20th January 2025

Mayfield, Plot M ('Republic'), Manchester – Application for Amendments via Variation of Condition to Planning Permission for 137349/JO/2023

Figure 1.1: Key Design Changes to External Façade and curtain walling

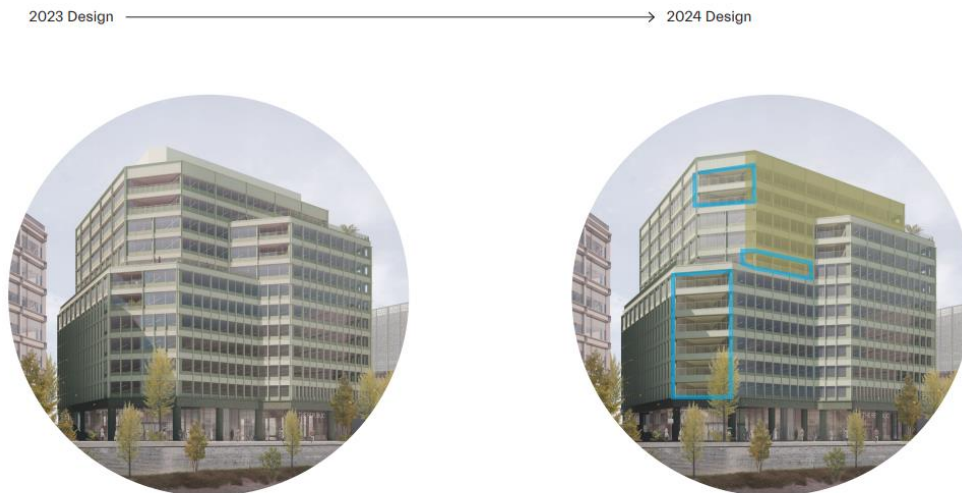
- **External Appearance:** To enhance the building's sustainability and commercial appeal, loggias have been introduced on levels 1 to 4, providing a direct visual connection to Mayfield Park. This design element has also been extended to levels 5, 6, 10, and 11, ensuring a consistent and attractive architectural feature throughout and to provide tenants on each floor with external amenity space. For improved functionality and safety, external loggia doors are now inward opening, with additional doors incorporated at the larger terraces on levels 7 and 10. The inclusion of the loggias results in a minor decrease in floorspace from 32,989 sq. m. to 31,988sqm (GEA; 1,001 sq. m. or 3% decrease).

- **Façade detailed design:** Updates to the detailed façade design have incorporated inputs from a specialist façade sub-consultant as well as further co-ordination with the consultant design team. The key change to the façade design relates to the delivery of a unitised system in order to improve the quality of finishes to the building envelope. The proposed façade system does not impact the architectural design intent or the external appearance of the consented scheme with fin depths being maintained, but it does provide further carbon savings.
